## MEMORANDUM

**RE:** Clompus 2016-02 Continued Hearing

**STAFF REPORT: CITY OF TRINIDAD**

PROJECT DESCRIPTION: Design Review, Coastal Development Permit, and Grading Permit to construct a new 1,236 sq. ft., 2-story, 1-bedroom, single-family yurt (permanent construction). A new 2-bedroom sewage disposal system will also be installed.

**Title:**  
 ELEVATIONS

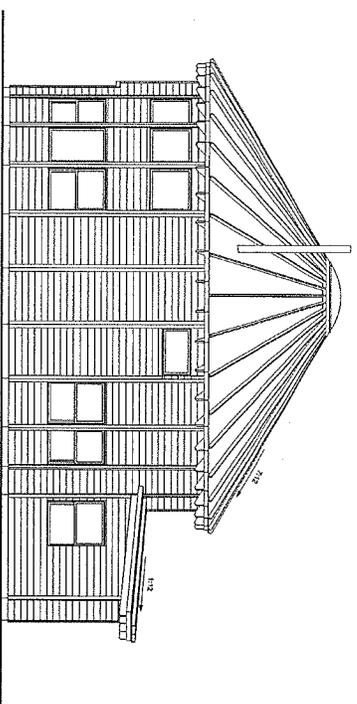
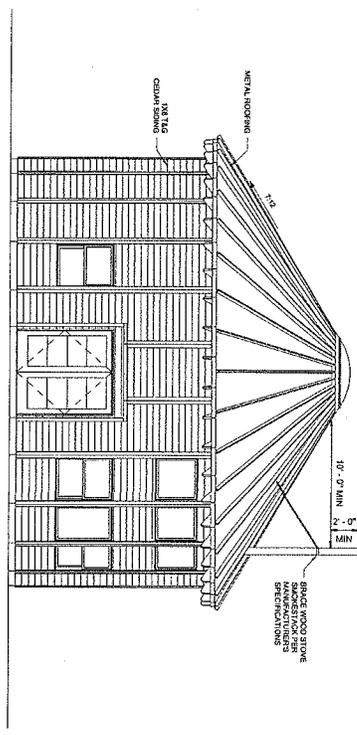
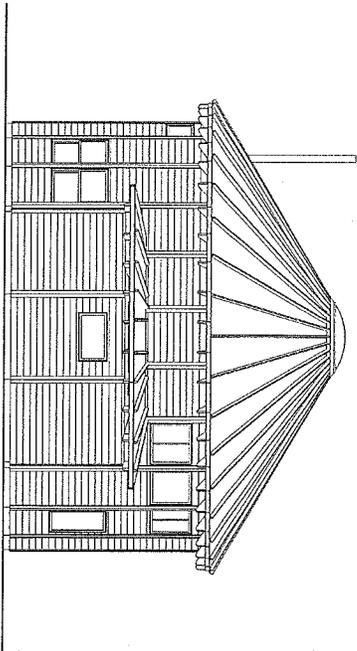
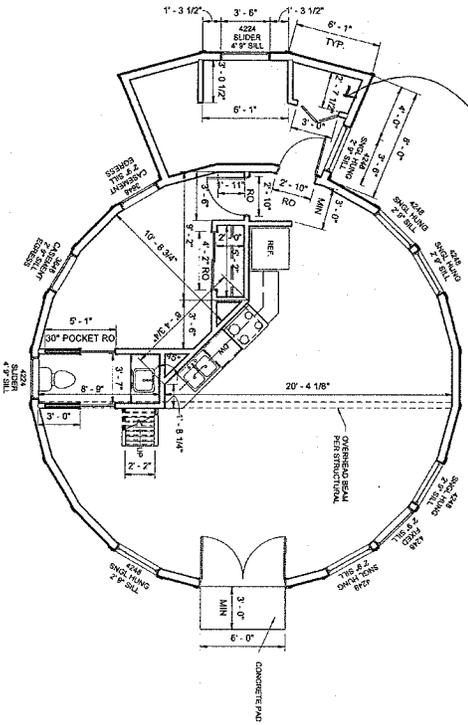
is 24 ft. However, it appears that this was measured from the top of the foundation rather than the ground surface. On the provided elevation, it appears that the foundation is not more than a foot in height, but the scale is not exact. Views are not likely to be an issue for this project due to the surrounding vegetation. But to ensure compliance with the zoning ordinance, a condition of approval has been included that the maximum height from the average ground elevation can not exceed 25 ft.

10. Applicant shall direct roof drainage downspouts away from the septic system tank and leachfield. *Responsibility: Building Official to confirm at time building permits are issued.*
11. Applicant to provide method for City to verify height measurements (such as a reference stake) before and during the roof framing inspection and upon project completion. The addition shall not exceed 25' from the average ground elevation. *Responsibility: Building Official to confirm at time building permits are issued and during construction inspections.*
12. Applicant shall redesign the raised stoop so that it does not extend into the side yard setback by more than 3 feet. *Responsibility: Building Official to confirm at time building permits are issued.*

**PLOT PLAN**

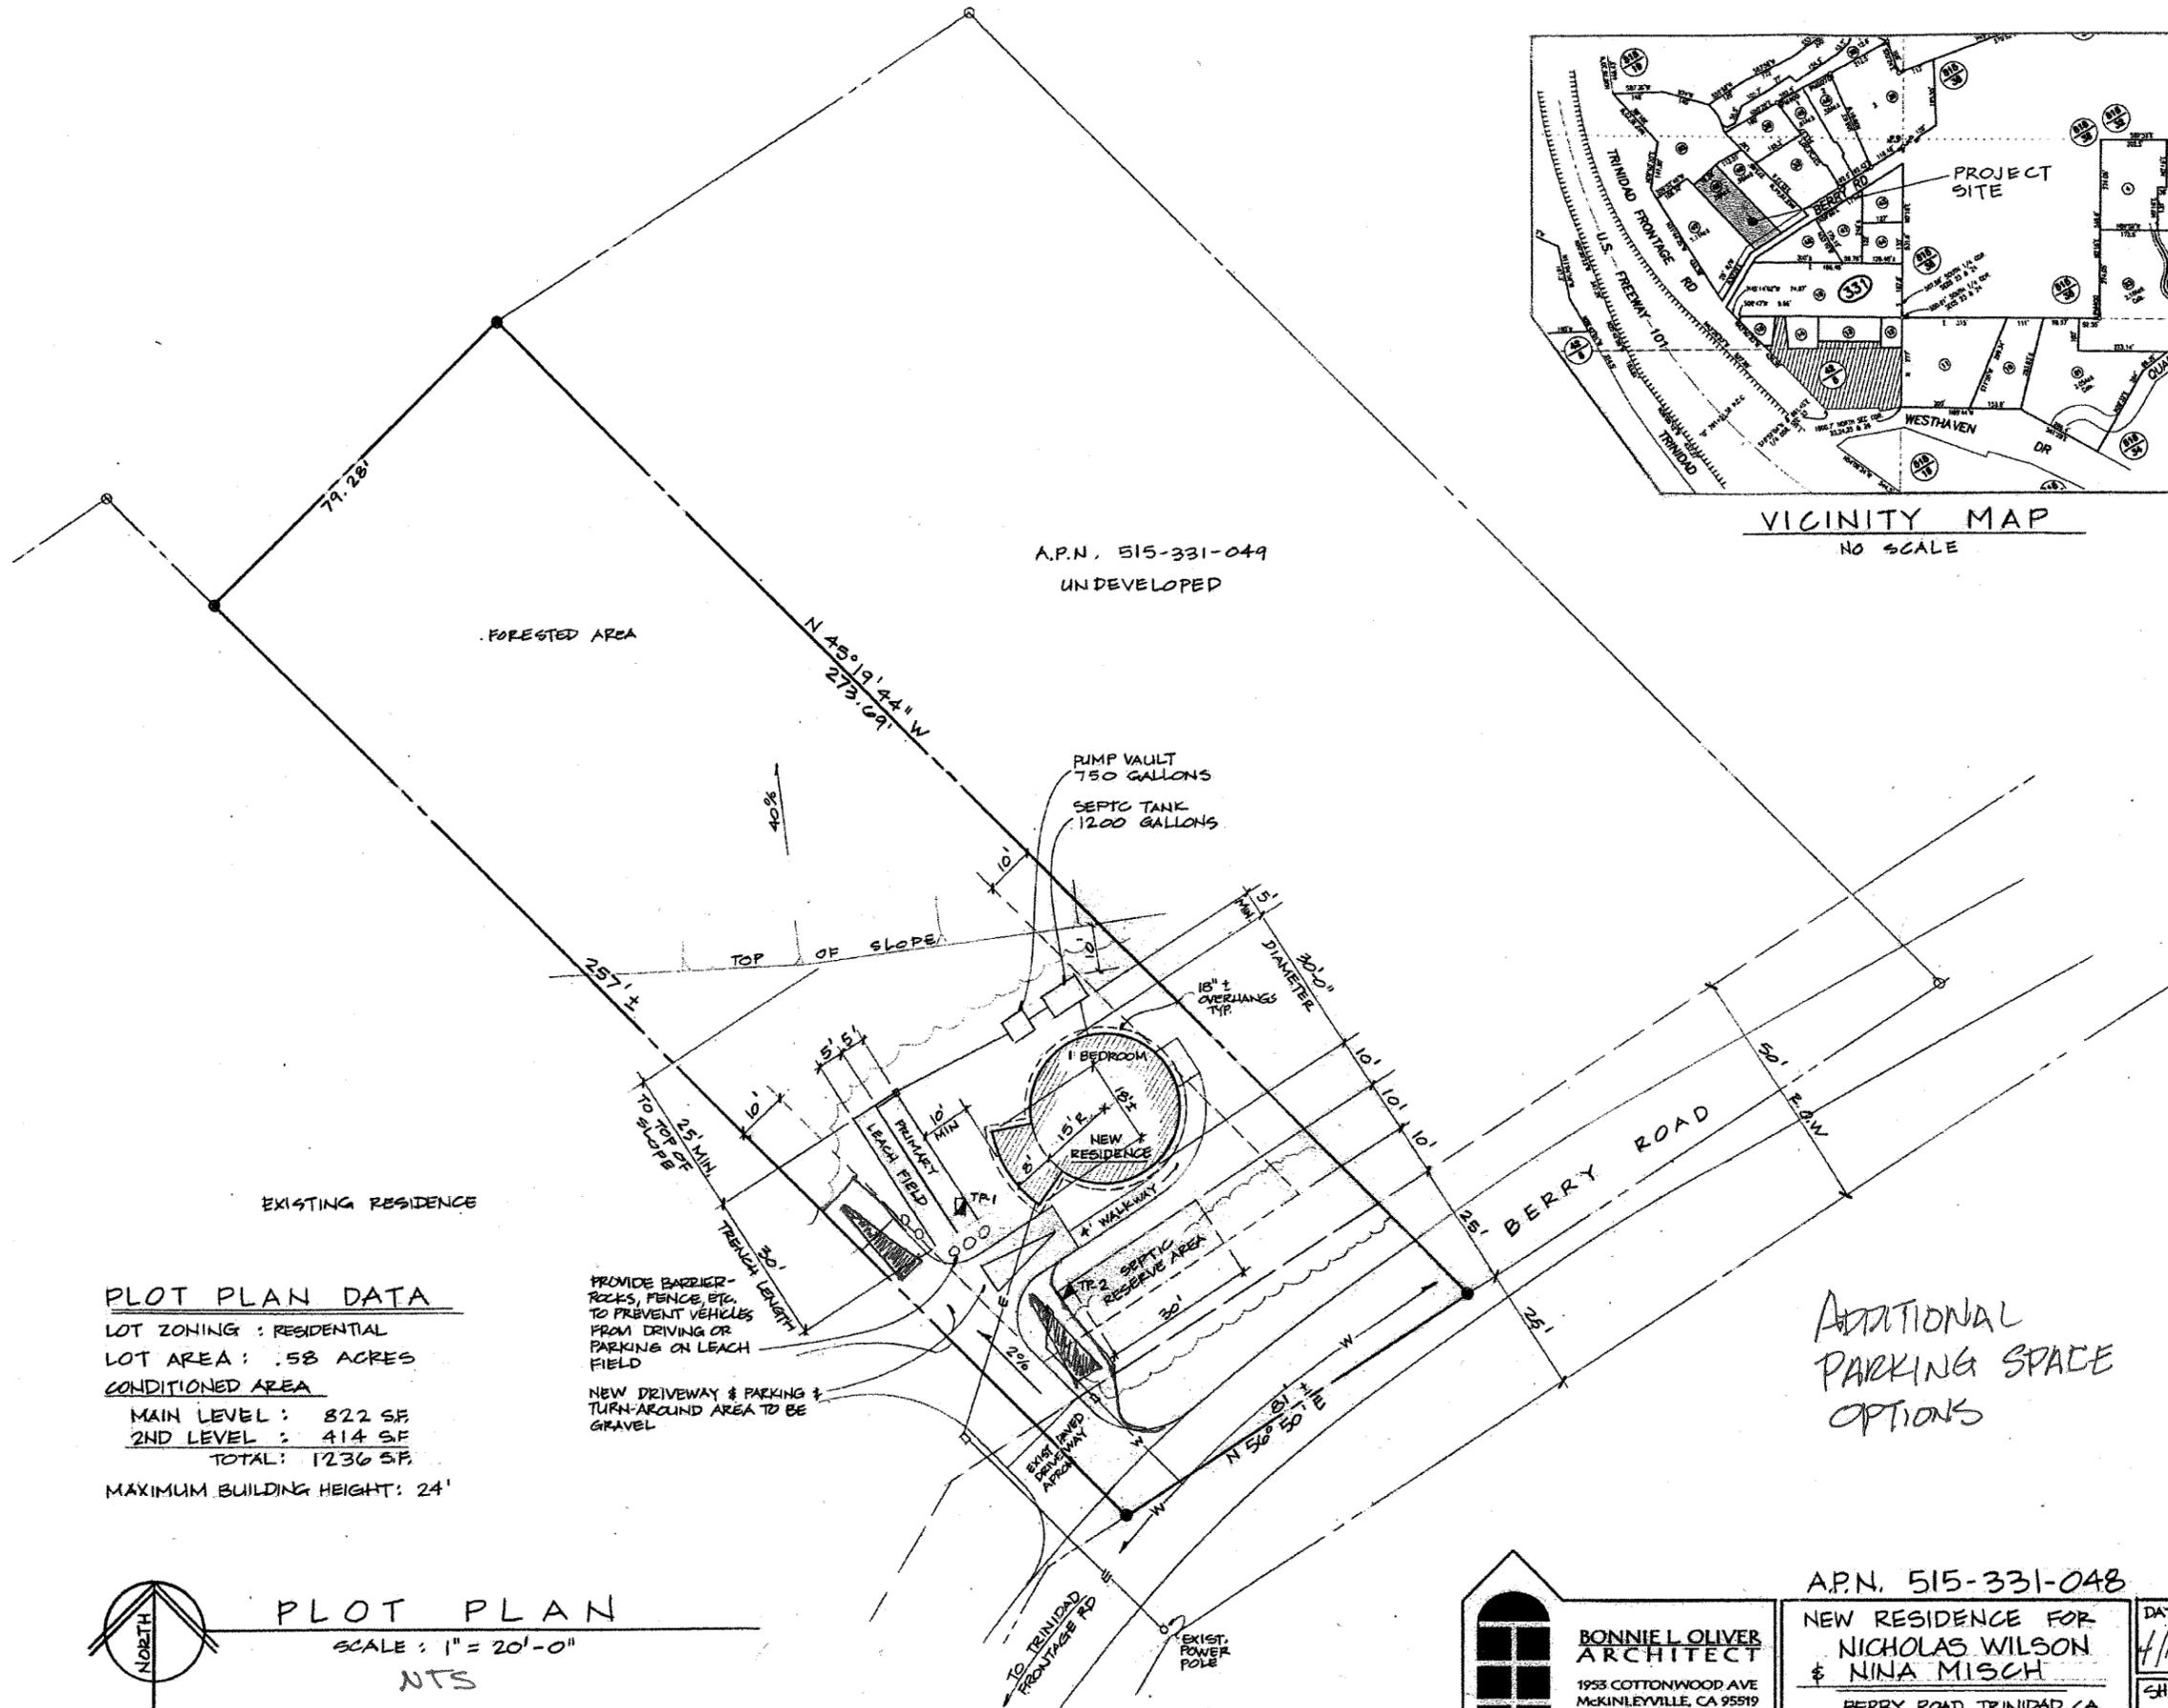
The Zoning Ordinance (§ 17.56.180) requires 2 off-street parking spaces other than any garage spaces; spaces must measure 8.5' x 18'. The originally submitted plot plan shows only one parking space. Normally, tandem spaces in the driveway are acceptable, but because this is a shared driveway, that would not be ideal. At 20' in width though, 10' on each property, the driveway is large enough to accommodate two cars. A revised plot plan was submitted showing two alternatives for accommodating an additional parking space. Both comply with the zoning ordinance requirements. Driveways and parking areas that accommodate less than 4 spaces must be surfaced with an all-weather surface. Compacted gravel complies with this requirement and still allows some permeability. The first 15' or so of the driveway is paved to reduce the amount of dirt and gravel being transported onto Berry Road. Runoff will need to be further addressed as part of the required drainage and erosion control plans, which will be reviewed as part of the building plans.

The proposed 2-bedroom septic system layout has been shown on the plot plan. The engineered design has already been approved by the Humboldt County Division of Environmental Health and permit issued by DEH for construction. Although the home is described as being only one bedroom, DEH requires most systems to be designed for at least 2-bedrooms. Due to the loft space and size of the residence, the City would have required a 2-bedrooms system as well. The system has been adequately sized and approved to serve two bedrooms. Note that normally a 10' setback is required between structures, including driveways, and a leachfield. Because the driveway is gravel, the setback is not required. However, the leachfield must be protected from vehicular traffic by a barrier, which is shown on the site plan and included as a conditions of approval.

7. The leachfield shall be protected from compaction and future disturbance with the construction of an appropriate barrier (e.g. large rocks, fence, etc.) between the leachfield and the driveway / parking / turn-around to be installed to the satisfaction of the building inspector. In addition, the driveway will be constructed with gravel and not paved, so as not to be considered a structure which would require a 10' setback from the leachfield. *Responsibility: Building inspector is to inspect and sign off on the barrier installed between the driveway and the leachfield as indicated on the site plan.*

PROVIDE BARRIER-ROCKS, FENCE, ETC. TO PREVENT VEHICLES FROM DRIVING OR PARKING ON LEACH FIELD

ADDITIONAL  
PARKING SPACE  
OPTIONS
